Project/File: **47th Street Apartments/ GC23-0003/ DSRFY2022-0022**
 This is a design review application to allow for the construction of 6 multi-family residential buildings, consisting of 60 townhomes and parking on 2 acres.

Lead Agency: City of Garden City

Staff Approval: February 1, 2023

SITE PLAN

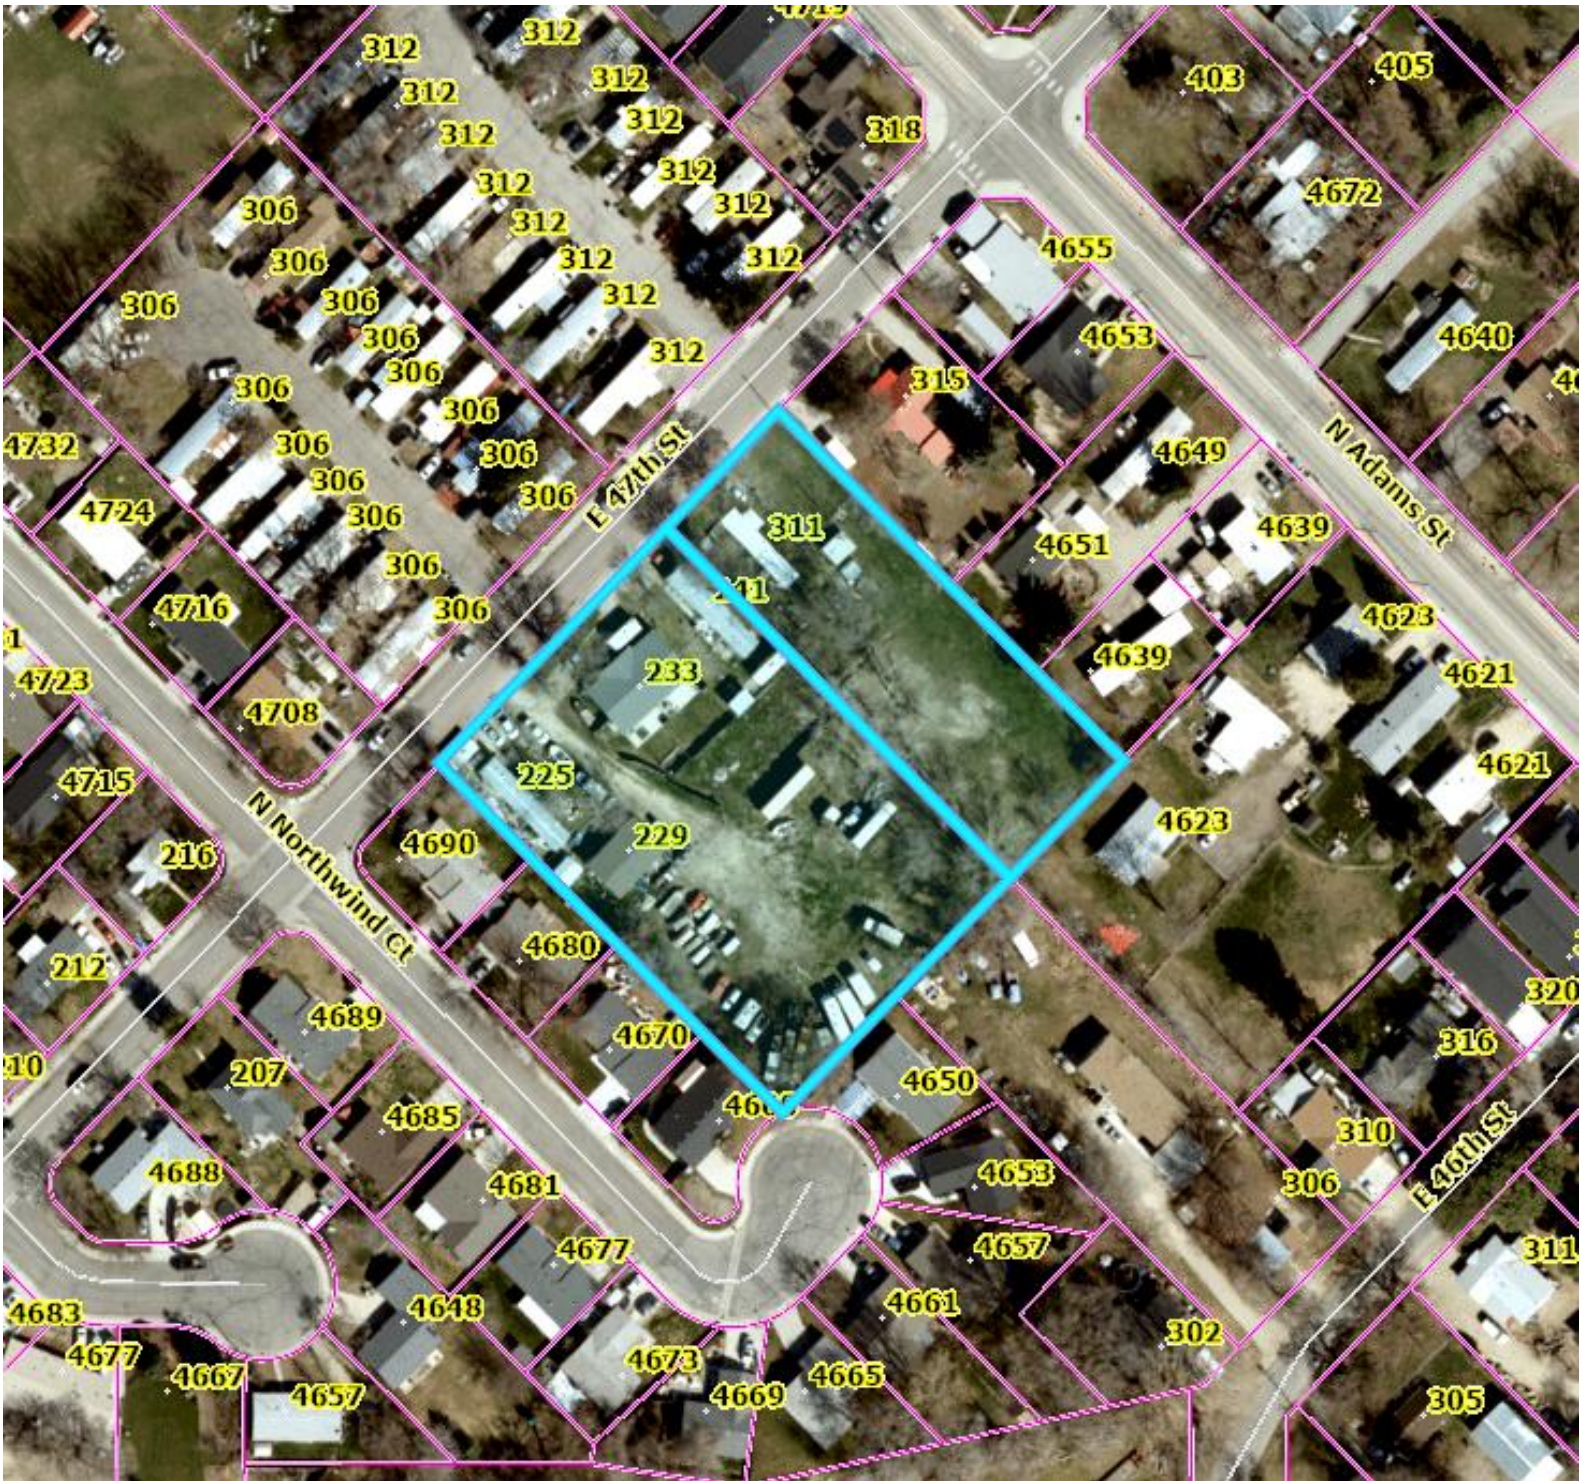
- c. **Applicant's Proposal:** The applicant is proposing to close all existing unimproved driveways onto 47th Street with rolled curb, gutter and 5-foot wide attached concrete sidewalk to tie into the existing improvements on either side.

The applicant is proposing to construct two new 22-foot wide curb cut type shared driveways onto 47th Street located as follows:

- Driveway 1. 22-foot wide driveway is 451-feet west of Adams Street.
- Driveway 2. 22-foot wide driveway is 299-feet west of Adams Street.

- d. **Staff Comments/Recommendations:** The applicant's proposal to close the five existing driveways onto 47th Street meets District policy and should be approved, as proposed.

The applicant's proposal to construct two new 22-foot wide curb cut type shared driveways onto 47th Street located 451 and 299-feet west of Adams Street meet District policy and should be approved as proposed. The two shared driveways should be constructed as paved curb cut type driveways.

3. Close all 5 existing unimproved driveways, located 478, 382, 351, 282, and 252-feet west of Adams Street onto 47th Street with rolled curb, gutter and 5-foot wide attached concrete sidewalk abutting the site as proposed.

4. Construct and pave two 22-foot wide curb cut type shared driveways onto 47th Street located 451 and 299-feet west of Adams Street.
5. Submit civil plans to ACHD Development Services for review and approval. The impact fee assessment will not be released until the civil plans are approved by ACHD.
